DEMOLITION HAMMER

Model HM1500

SERVICE CHANGE

2) Change on Brush Holder.

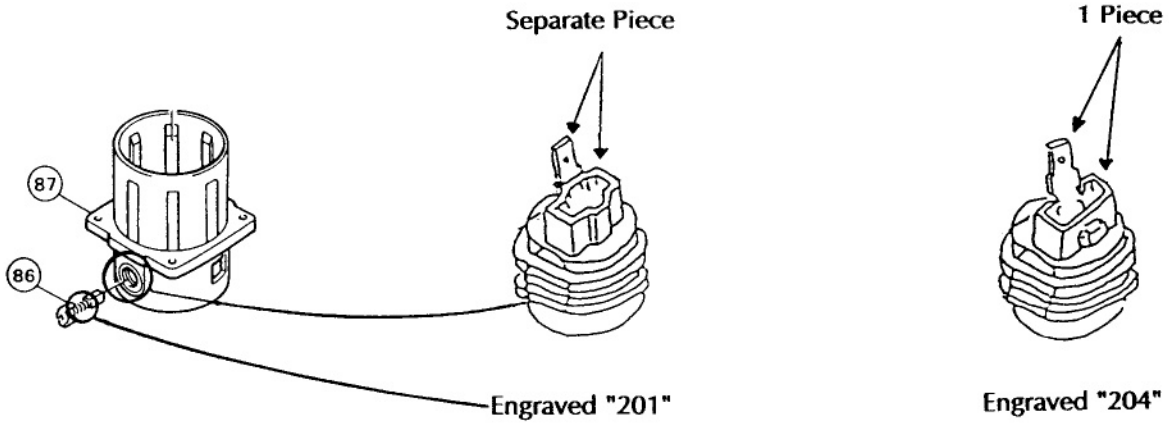
FIG.	DESCRIPTION	TYPE 1	TYPE 2	TYPE 3	TYPE 4
86	Carbon Brush	Part # 191944-6 CB-201 (Discontinued)	Part # 191957-7 CB-204	----------	----------
87	Motor Housing (Incl. Brush Holder)	Part # 159164-8 (Discontinued)	Part # 159631-3	----------	----------
		Part # 643703-9 (Discontinued)	Part # 643706-3 (Discontinued)	Part # 643931-6 (Discontinued)	Part # 643711-0

The above parts are interchangeable as a set.

3) Change on Tool Holder and Impact Bolt from S/N 8,682E.

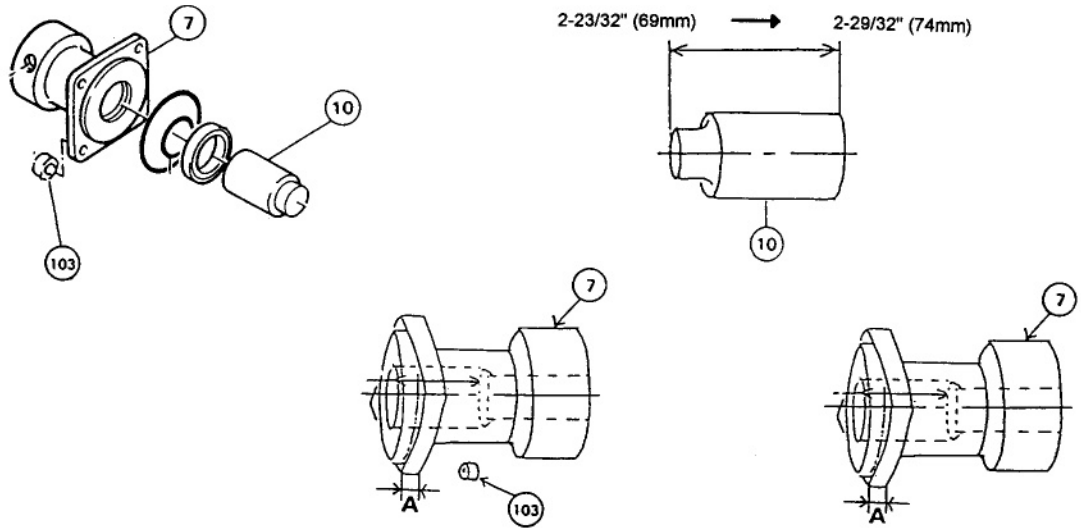
FIG.	DESCRIPTION	TYPE 1	TYPE 2
7	Tool Holder	Part #322514-2 (Discontinued)	Part #322692-8
10	Impact Bolt	Part #322384-9 (Discontinued)	Part #322693-6
103	Ring 12	Part #257182-1	----------

The above parts are interchangeable as a set.

4) Change on Impact Bolt Holder from S/N 173,41E on HM1500; S/N 5113E on HM1500B.

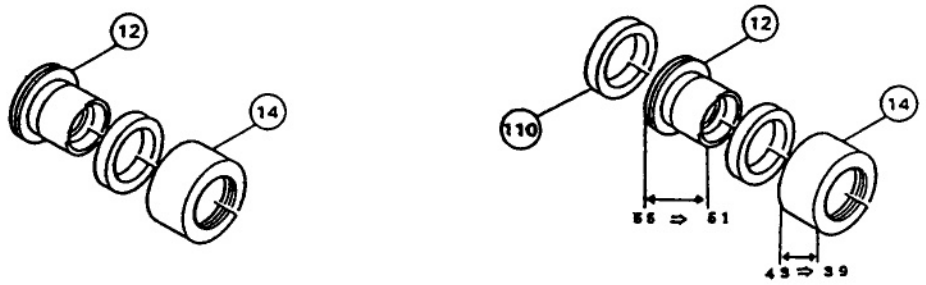
Fig.	Description	Type 1	Type 2
12	Impact Bolt Holder	Part #322385-7 (Discontinued)	Part #322931-6
14	Cylinder B	Part #322386-5 (Discontinued)	Part #322930-8
110	Nylon Washer 42	----------	Part #261105-3

The above parts are completely interchangeable as a set.
